# Contractor UPDATE

April 2023  
No:202302

## BauderSolar F XL mounting system

### Bauder have updated our BauderSOLAR F mounting system to BauderSOLAR F XL

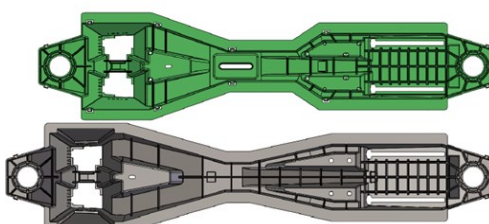
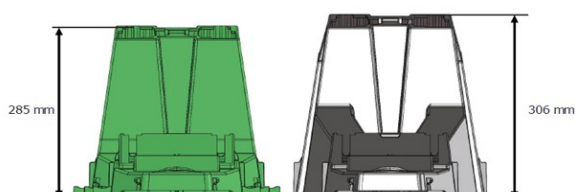
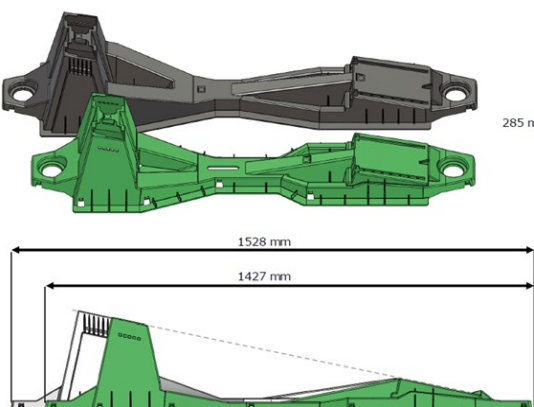
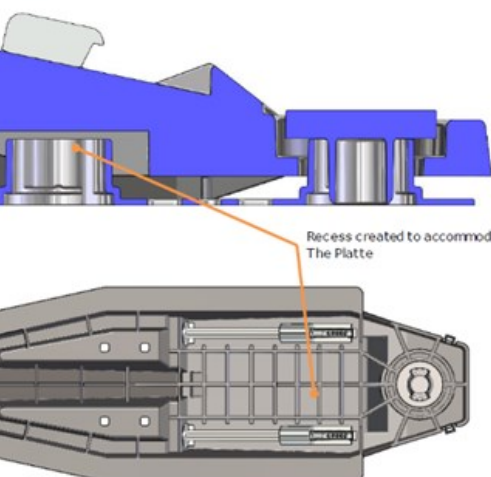
Please see page 2 of this contractor update for updated dimensions in comparison with the BauderSOLAR F mount.

BauderSOLAR F XL has a larger footprint, any existing designs will therefore need to be updated to suit. Please contact Bauders Technical Office if you would like us to provide an updated design for any projects you are working on.

Although the BauderSOLAR F XL is obviously larger, BauderSOLAR F & BauderSOLAR F XL look very similar. The easiest way to identify the two systems apart when on site is that the new BauderSOLAR F XL has a Bauder embossed logo on the rear of the mount.

- We have amended the mount structure so that the base plates can be pushed underneath the mount at both the front and rear of the array, reducing trip hazards
- We have reduced the number of eyelets for cable ties
